Addendum to the final report for “Contribution of Particle Emissions from a Cement-Related Facility to Outdoor Dust in Surrounding Community”

Prepared by
Zhi-Hua (Tina) Fan, PhD
Chang Ho Yu, PhD
Paul J. Liroy, PhD

July 16, 2009

Figure S1. A wind rose plot acquired from the nearby Philadelphia International Airport for the duration of 5 years (source: NJDEP)

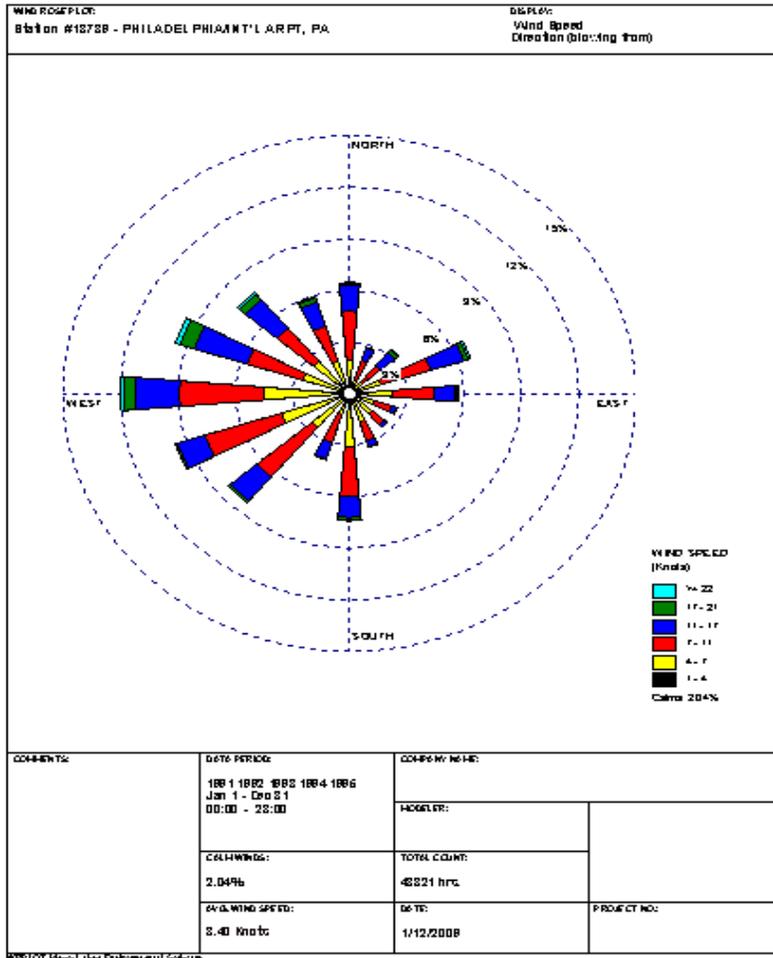
Are the wind patterns the same throughout the year?

From the nearby airport meteorological data, the main wind direction is from west (ranging from southwest to northwest) and consistent throughout the year. Please see Figure S1 below for general wind patterns in the study area.
